**Flood Control Project Maintenance
Levee Inspections
LMA District Cover Sheet
Spring 2012 Levee Inspection Results**

Reclamation District No. 0003 Grand Island

Levee Inspection Report By Mile - Spring 2012

Waterway			Bank	Unit Miles	Inspection Start/End	Inspector
Unit No. 01 Left Bank Steamboat Slough			Left	11.03	03/20/2012 03/21/2012	Richard Willoughby

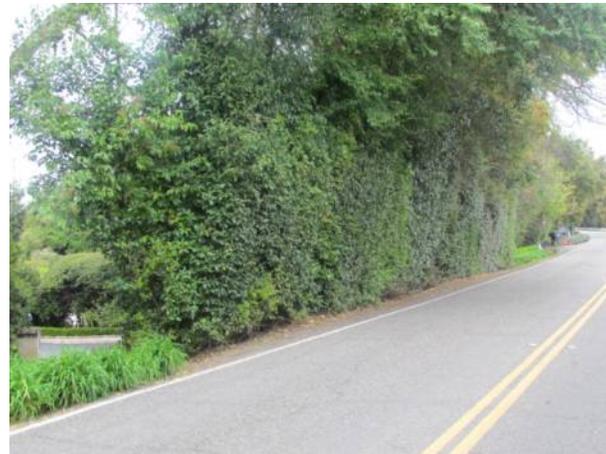
Levee Mile Report Line	67
Start Levee Mile	12.48
End Levee Mile	12.55
Location	Land Side
Category	Earthen Levee
Item	Vegetation
Looking northwest at dense landscaping on landside shoulder.	
richard_s_20120328_173.jpg

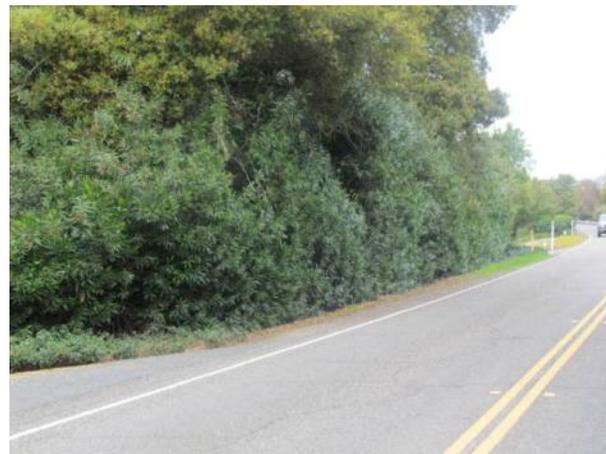
Levee Mile Report Line	69
Start Levee Mile	12.60
End Levee Mile	12.63
Location	Land Side
Category	Earthen Levee
Item	Vegetation
Looking northwest at dense landscaping on landside shoulder and slope.	
richard_s_20120328_174.jpg
